LivableStreets

Bicycle +
Pedestrian
Advisory Board

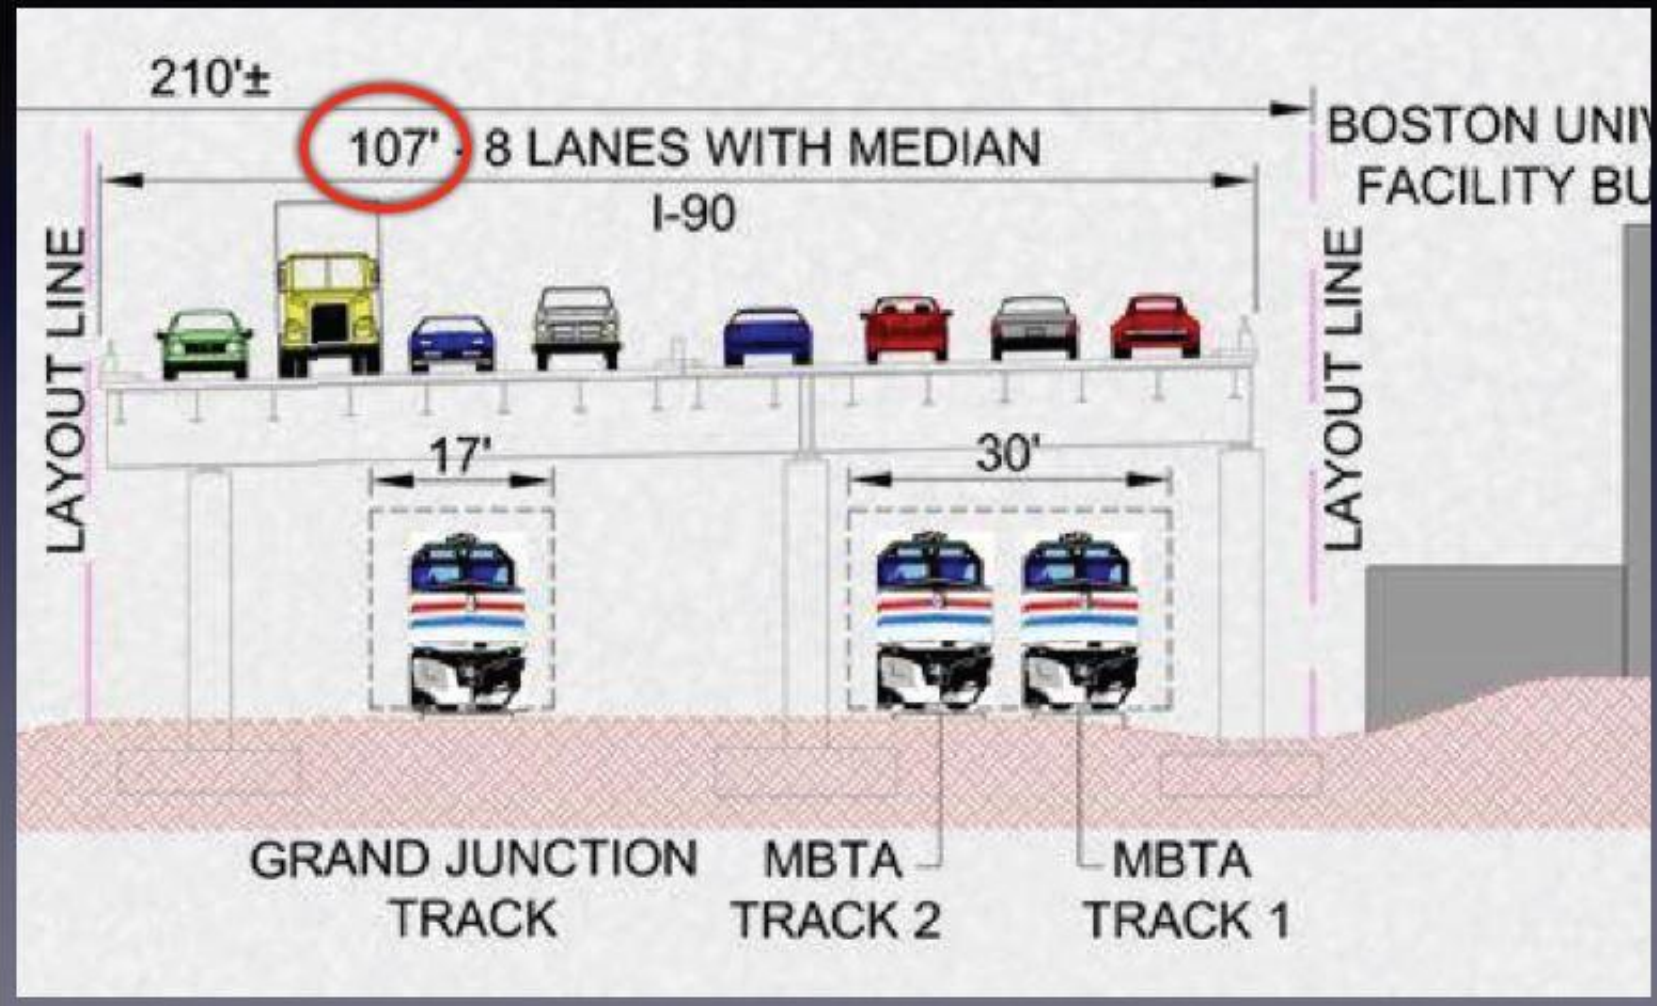
107' wide

+23' wider = 130'

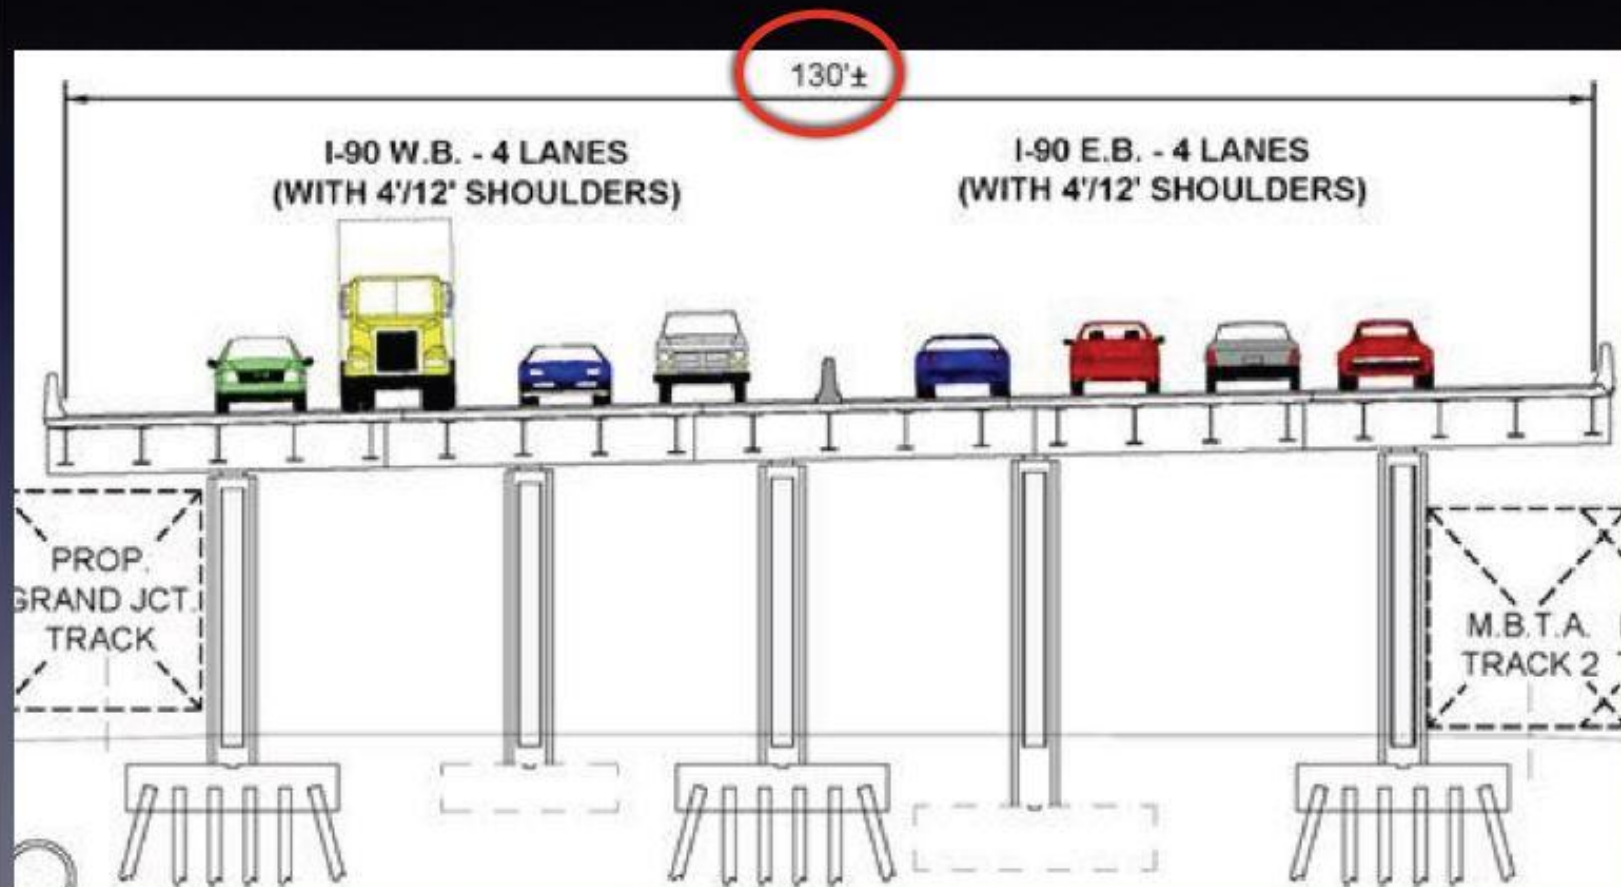
30' into Parkland

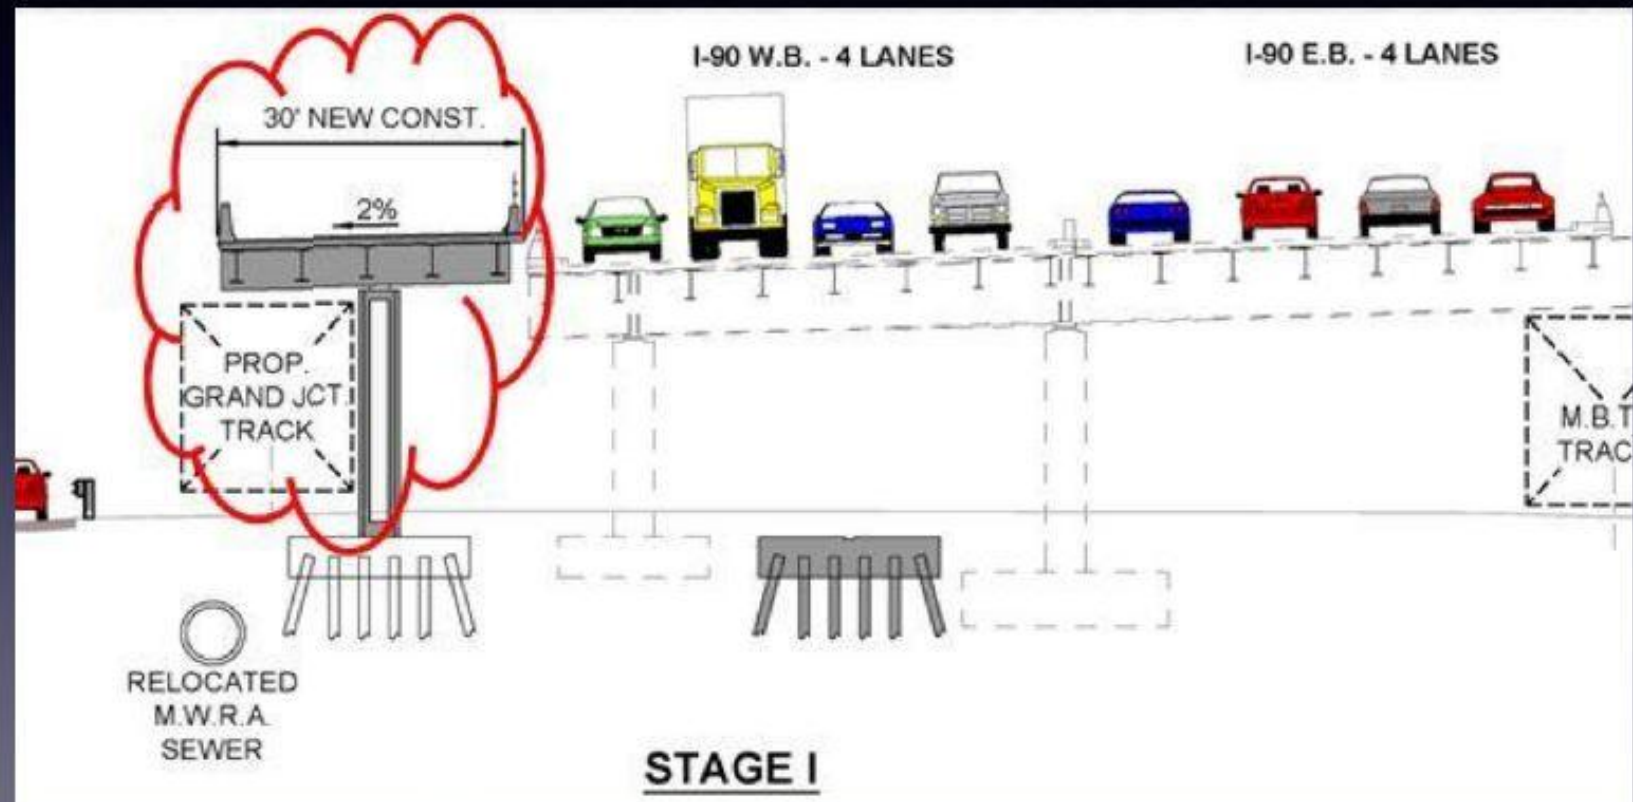
Stage 1 of 6?

I.V.A.S.

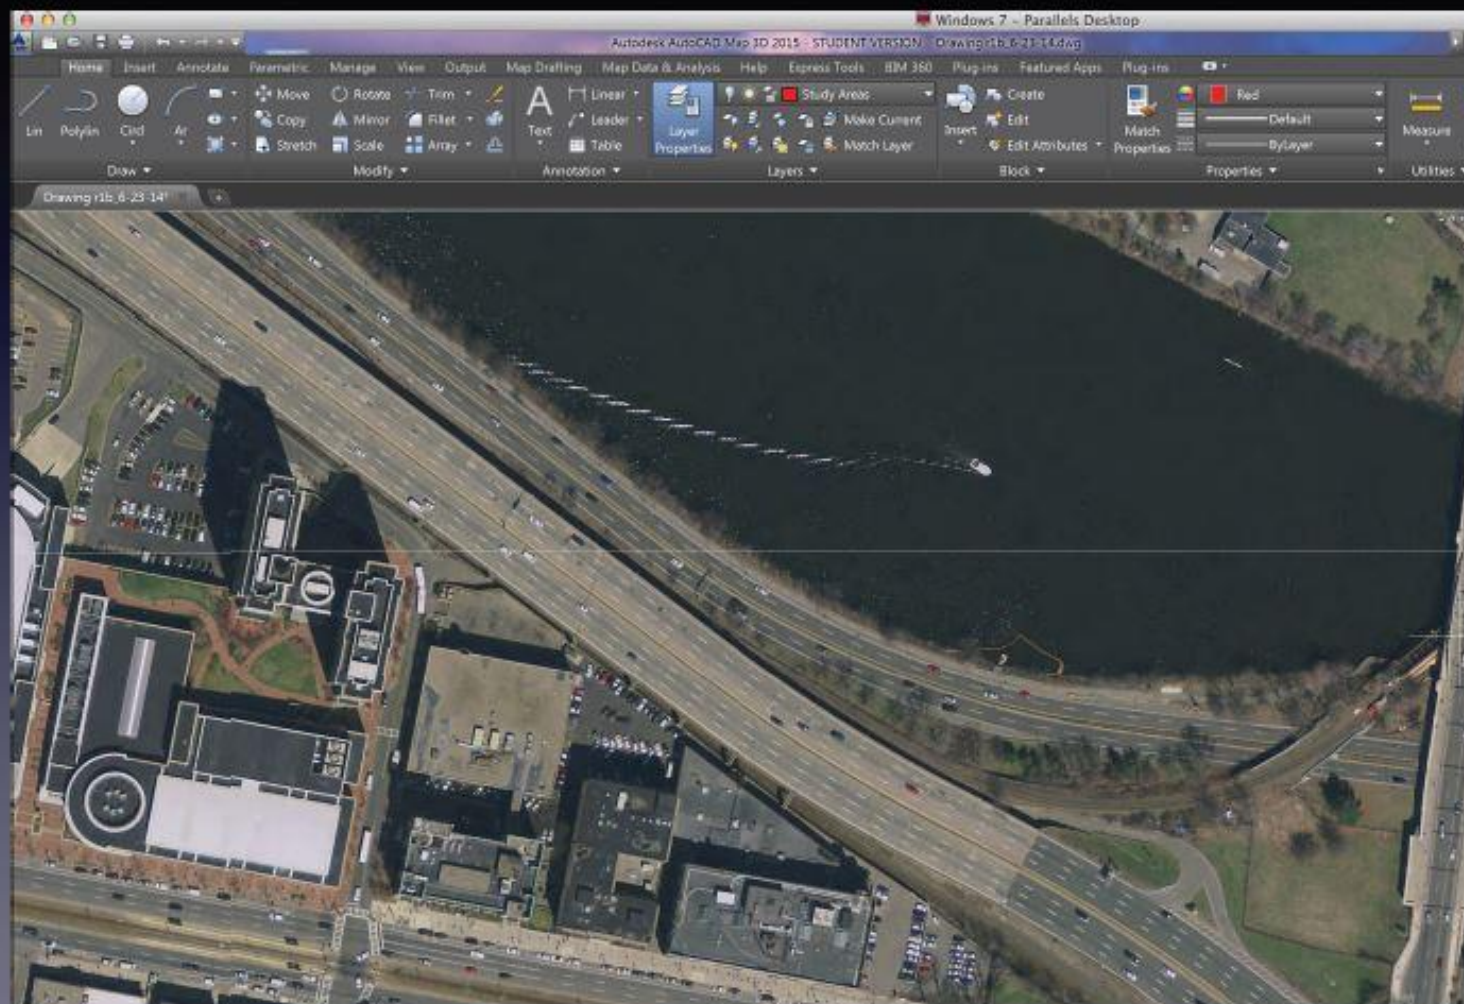
+10.9'

10.0'

+2.0'

$$\begin{array}{r} 10.0' \\ + 2.0' \\ \hline 12.0' \end{array}$$

Option 1: S x S

- $107' + \sim 12' = 119'$
- Place GJ under
